RE: PROPOSED ALRT LINE THROUGH THE BYRNE CREEK RAVINE:
PROVISION FOR THE POSSIBILITY OF CONSTRUCTION OF THE EDMONDS EXTENSION
(ITEM 22 SUPPLEMENTARY REPORT NO. 37, 1983 MAY 24)

TO: MUNICIPAL MANAGER 83 07 05
FROM: DIRECTOR ENGINEERING
SUBJECT: PROPOSED ALRT LINE THROUGH THE BYRNE CREEK RAVINE:
PROVISION FOR THE POSSIBILITY OF CONSTRUCTION OF THE
EDMONDS EXTENSION

SUBJECT: PROPOSED ALRT LINE THROUGH THE BYRNE CREEK RAVINE

**BYRNE CREEK RAVINE
 ALERT ALIGNMENT.**
 Burnaby Planning Department

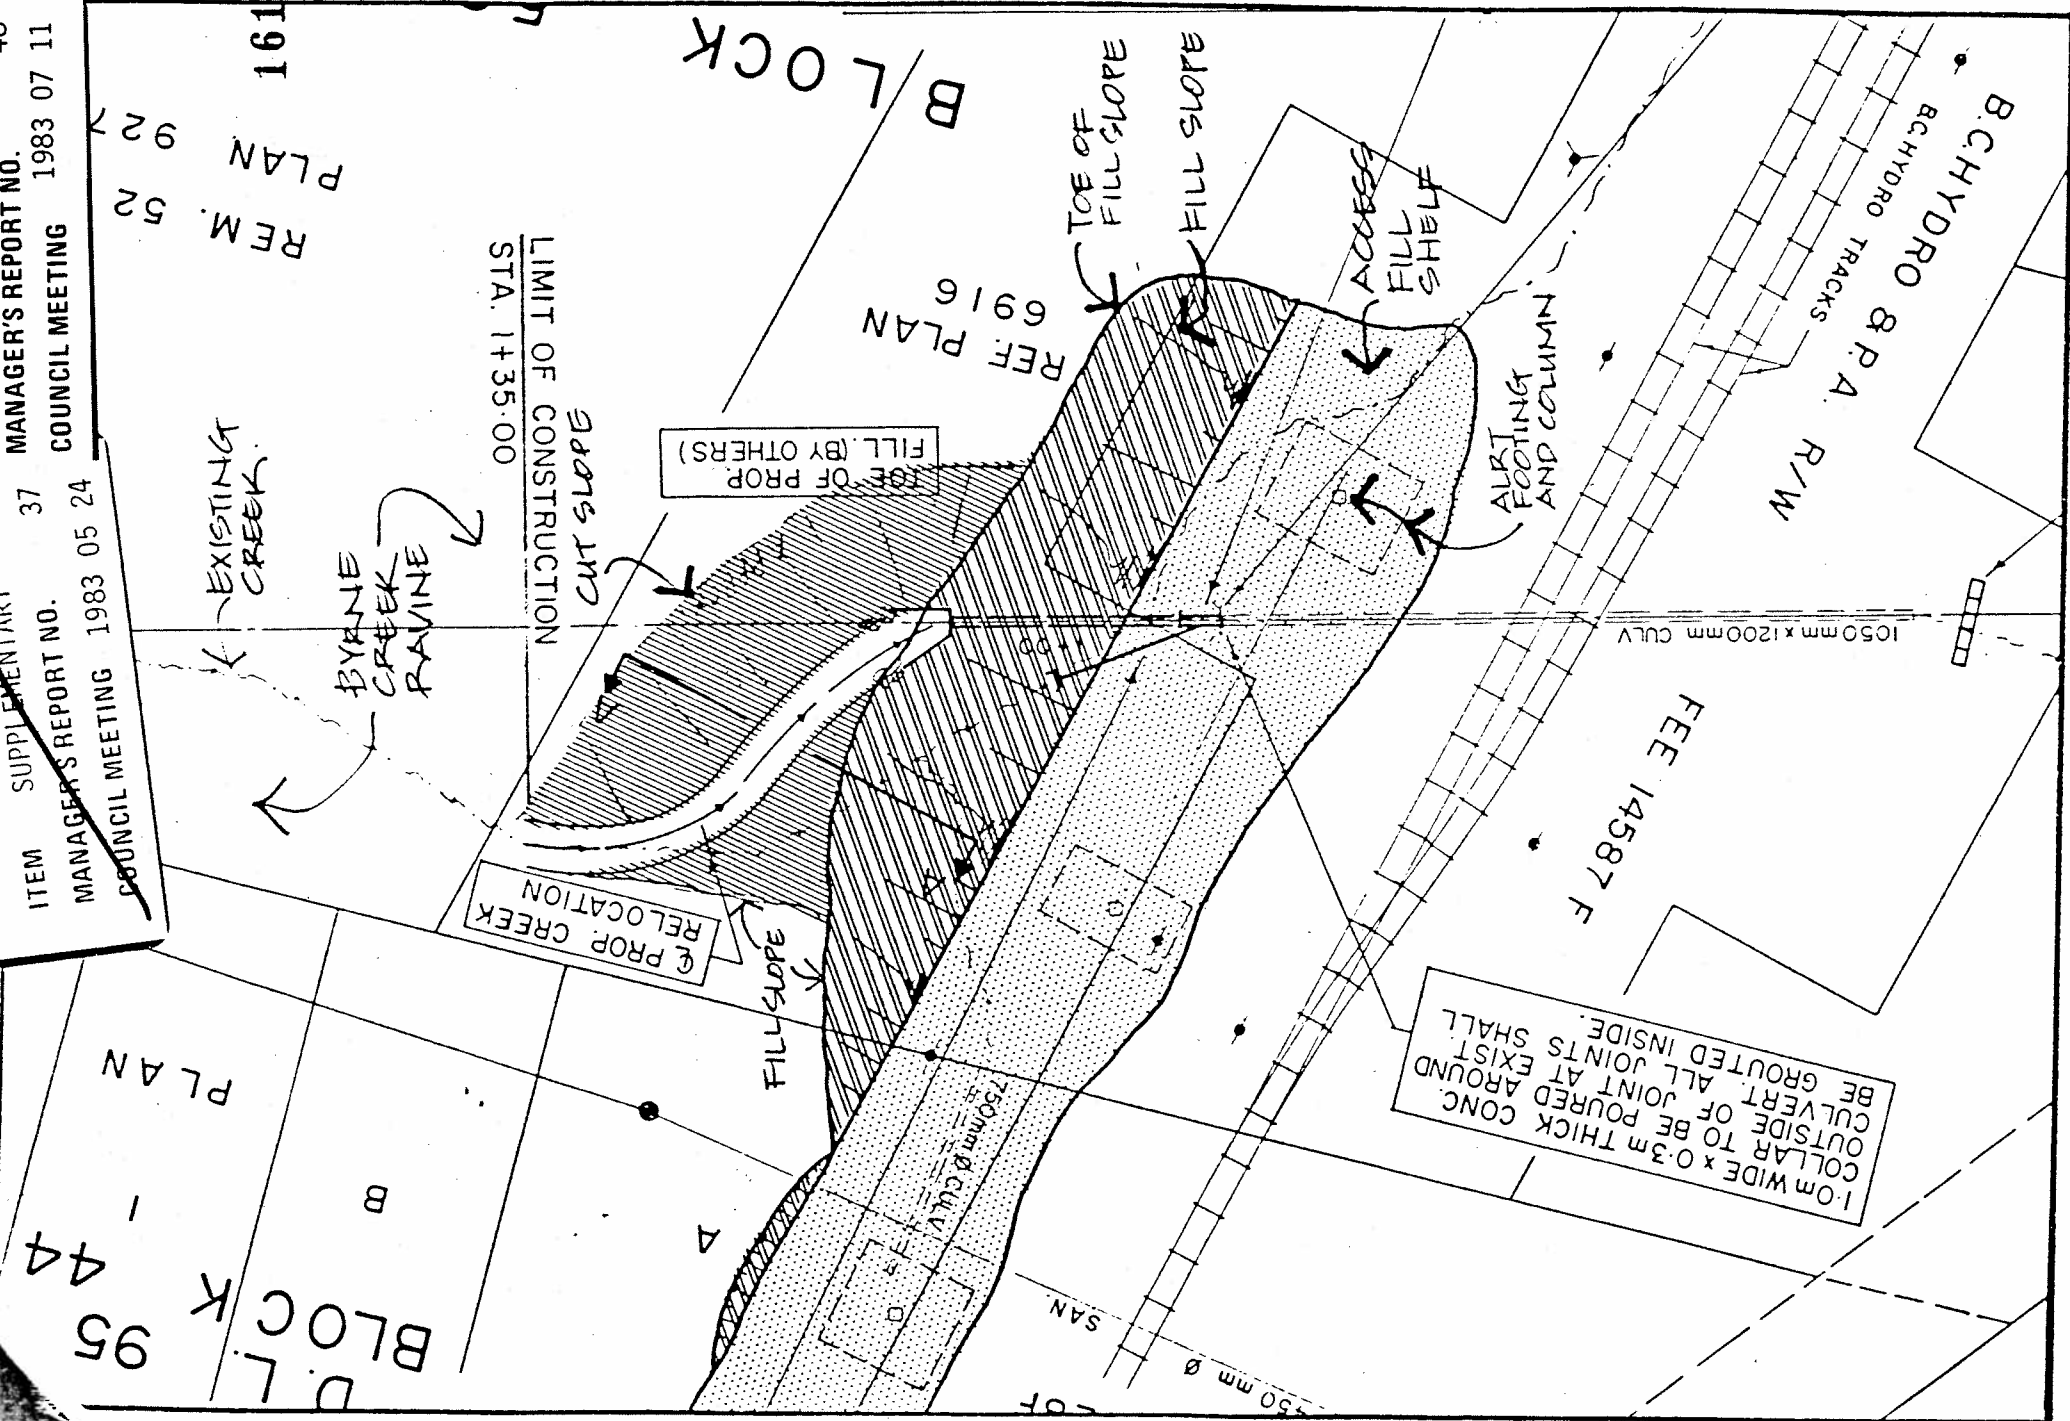
In response to this request and discussions with Municipal staff, B.C. Transit has submitted the attached letter dated 1983 May 17. B.C. Transit indicates that the fill shelf alongside the existing rail alignment is required for access to accomplish the placement of the guideway columns and beams for the ALRT. Therefore, it is proposed that the amount of fill and elevation of footings remain unchanged in accordance with the drawings provided by B.C. Transit.

Another point related to the Byrne Creek Ravine and outlined on the engineering sketches submitted by B.C. Transit is the proposed relocation of overhead B.C. Hydro distribution wires on poles (approximately 18 m from the centreline of the guideway alignment) further northeast into the ravine as a result of the ALRT guideway and filling. Another parallel 69 KV overhead line is outlined as a future proposal a further 10 m into the ravine. The consequence of these power line proposals would be to further affect the natural aspect of the Byrne Creek Ravine both from an undesirable visual point of view and also in the light of the common practice of clearing a swath beneath overhead power lines of existing trees and major foliage. Staff would recommend that the relocation of any power lines and new lines on an overhead basis should be kept to the west side of the B.C. Hydro tracks where an existing overhead line exists and then allowed to cross the ALRT guideway alignment in the vicinity of Griffiths Avenue. This alternative alignment would assist in preserving the very deep well-treed ravine area east of the ALRT guideway. It is our understanding that B.C. Hydro had originally preferred this alternative alignment. To avoid any crossing difficulties associated at the intersection of Griffiths Avenue with the ALRT guideway, the dipping of the B.C. Hydro line underground under the ALRT guideway similar to the arrangements for crossing electrical lines all along the ALRT alignment is considered appropriate. This matter has been discussed with B.C. Transit staff and B.C. Transit has agreed to examine this situation.

1. THAT Council accept the position of B.C. Transit as outlined in its letter of 1983 May 17 on condition that an appropriate extensive restorative and park/trail landscaping scheme for any disturbed areas as noted on the submitted engineering drawings (fill access shelf, fill retaining slope, creek realignment cuts and fills) be designed and constructed by B.C. Transit.

2. THAT the proposed relocated and new overhead power lines be kept on the west side of the B.C. Hydro tracks as originally indicated by B.C. Hydro, in order to preserve the Byrne Creek Ravine; and that B.C. Transit be requested to pursue this west side alignment.

Figure 2

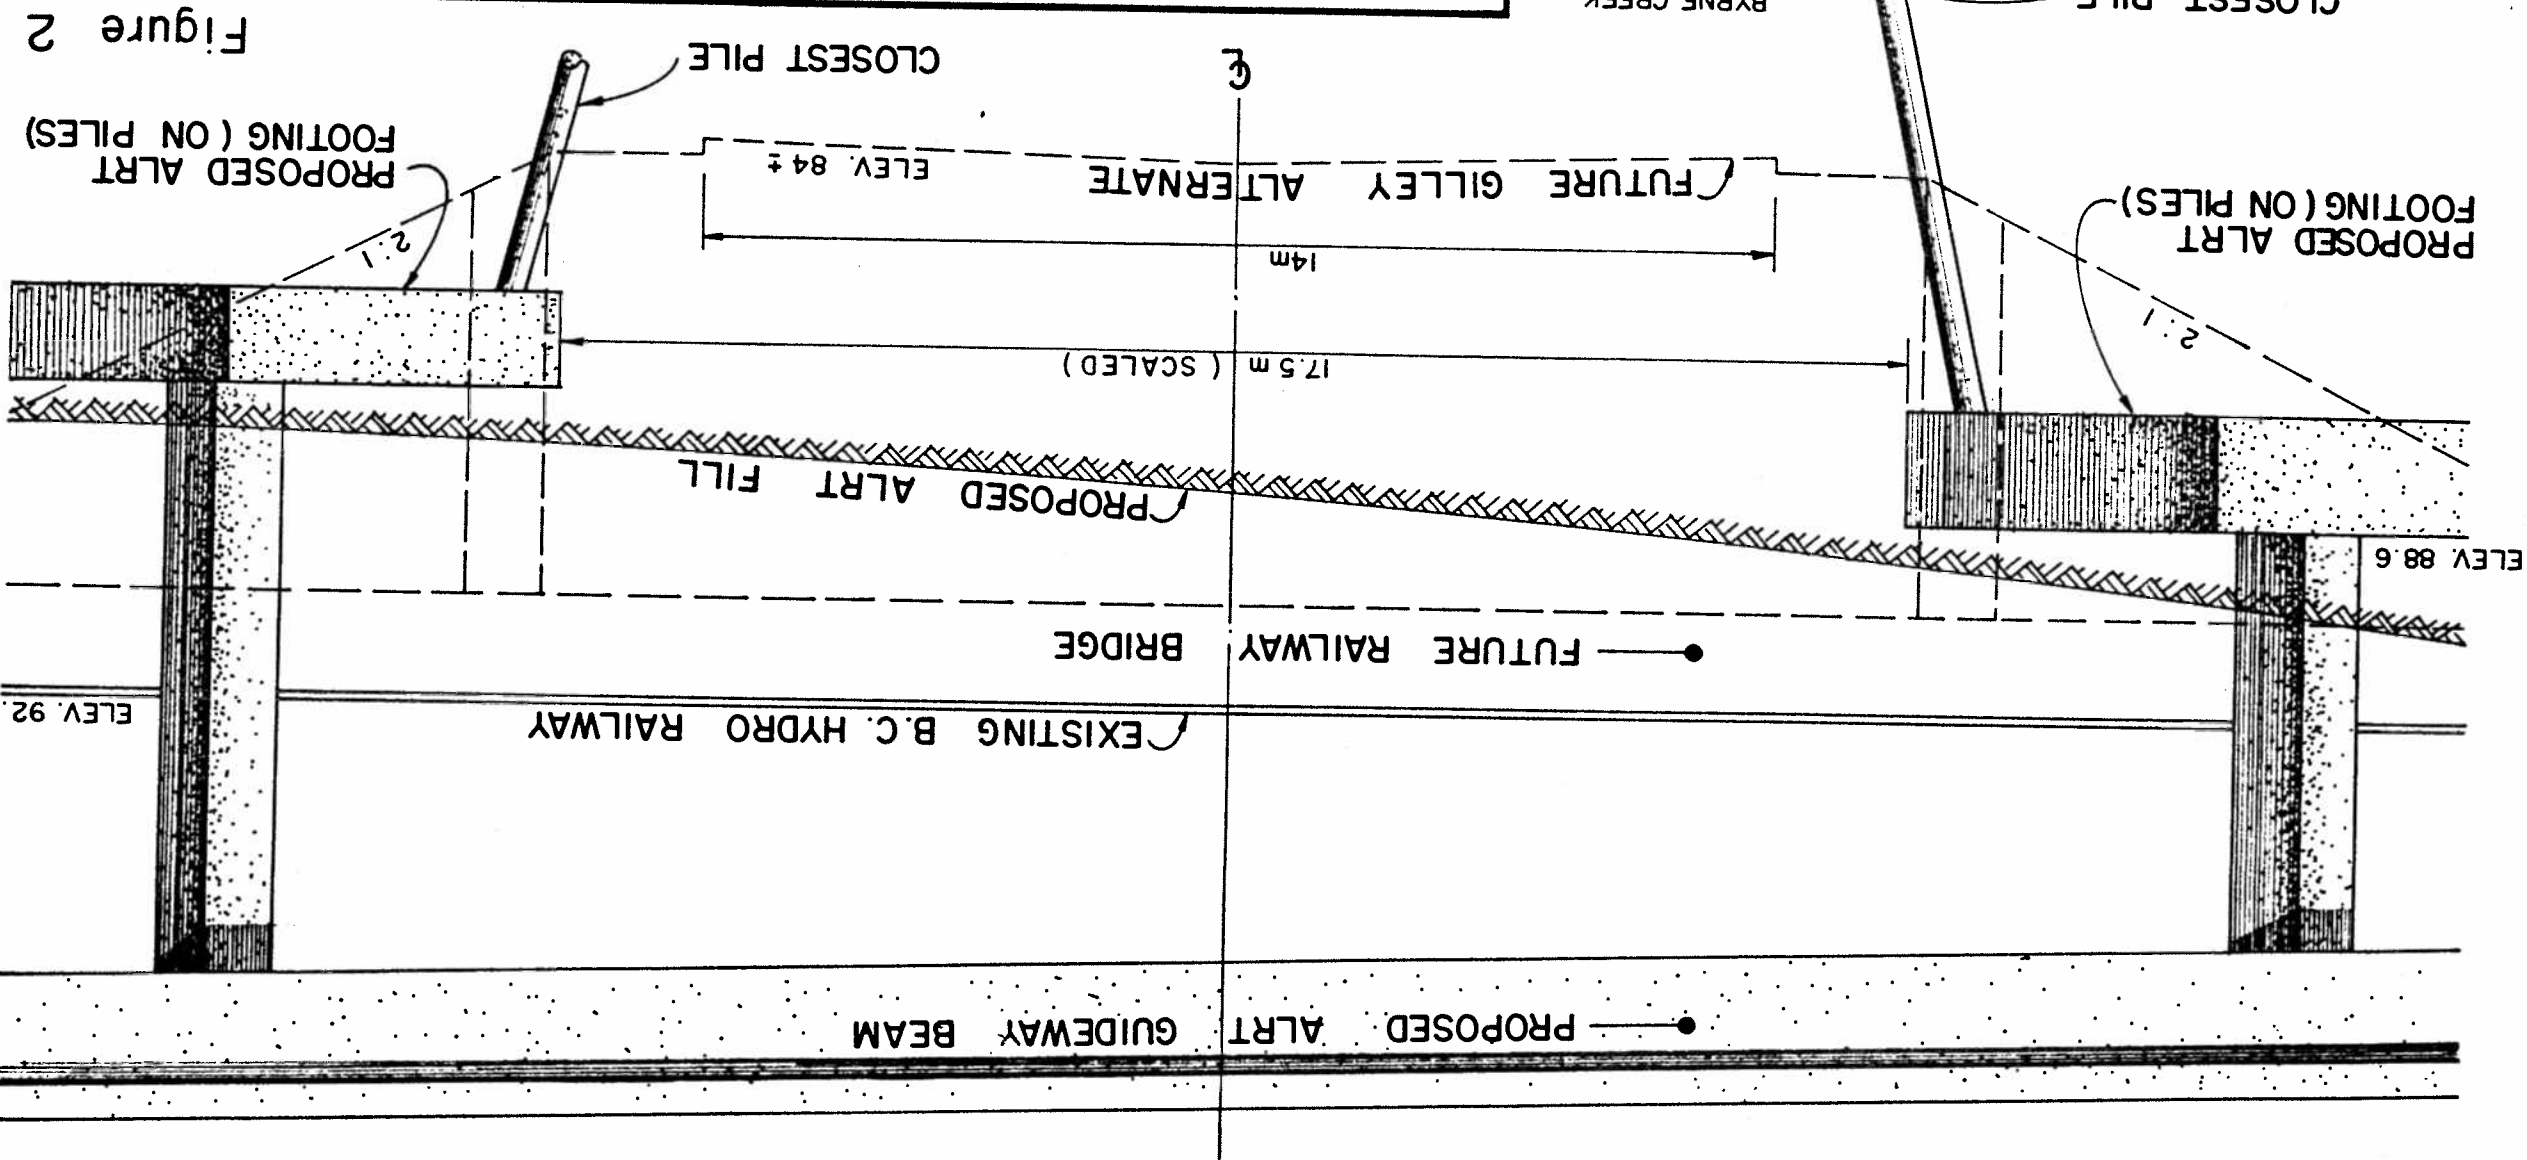
column footings as shown in the cross section (see Figure 2).

To accommodate the road, it will be necessary to excavate to road elevation and provide some means of retaining the fill beneath the footings during and after construction. Your Director Engineering considers such a construction technique to be technically feasible of being done at time of construction and, conversely, feels that pre-investment of public funds in protective works that would be "buried" pending the future uncertain need is not justified.

It is concluded that the Edmonds extension (Gilley Alternate) construction is technically feasible but some extra construction costs would result from the presence of the ALRT system. The precise amount of such costs could be independently determined as, if, and when the road proposal is advanced to the construction stage.

Figure 1
163

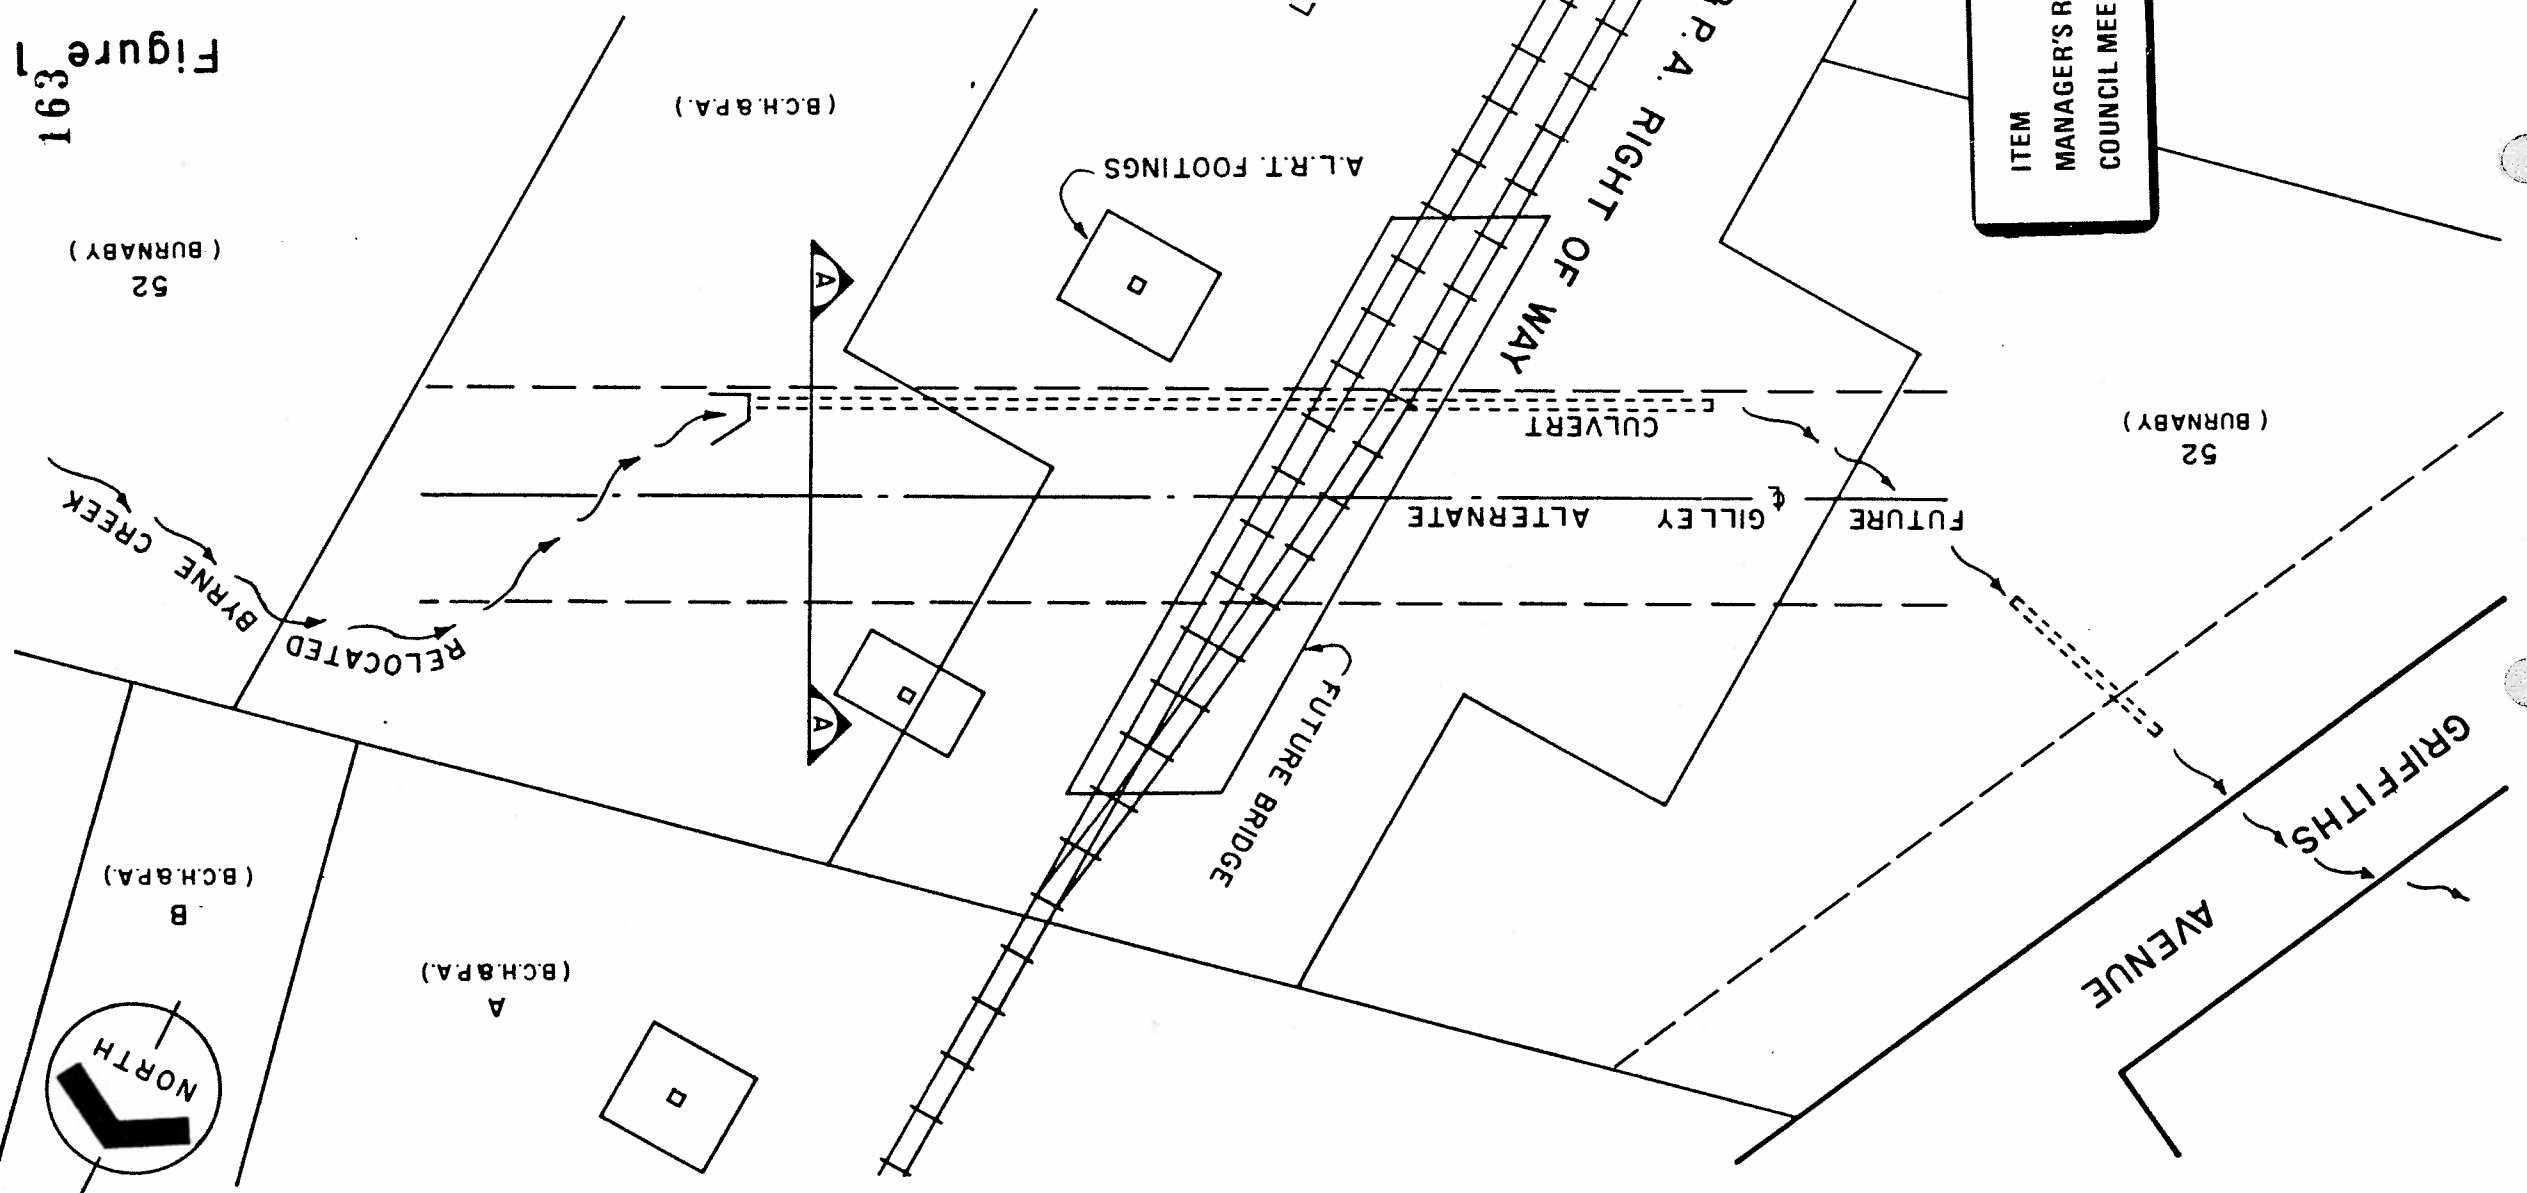
The ALRT columns and Byrne Creek are positioned so as to allow the possibility of the road to pass under the Advance Light Rapid Transit (ALRT) guideway in an alignment that is substantially the one proposed in preliminary design from the Gilley Alternate studies of several years ago (see Figure 1). However, the roadway elevation is considerably below the level of the ALRT
